TECHNICAL BULLETIN

[Issue No.] FA-A-0125 [Page] 1/3
[Title] A change in the rating plate of MELSEC-Q series modules
[Date of Issue] December 2011
[Relevant Models] QD65PD2, Q64TCTTN, Q64TCRTN

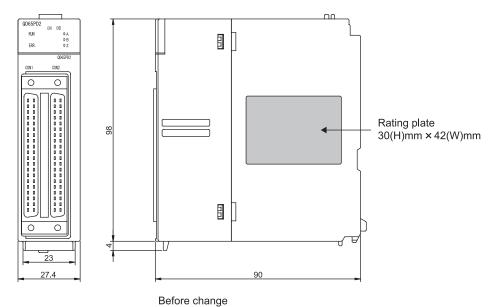
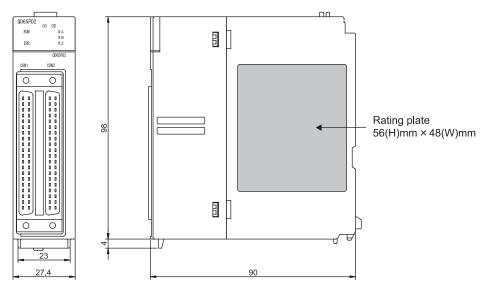
(1) Size

The size of the rating plate will be enlarged.

The figures below show the change in the QD65PD2.

For the Q64TCTTN and the Q64TCRTN, the same change as the QD65PD2 will be applied.

After change
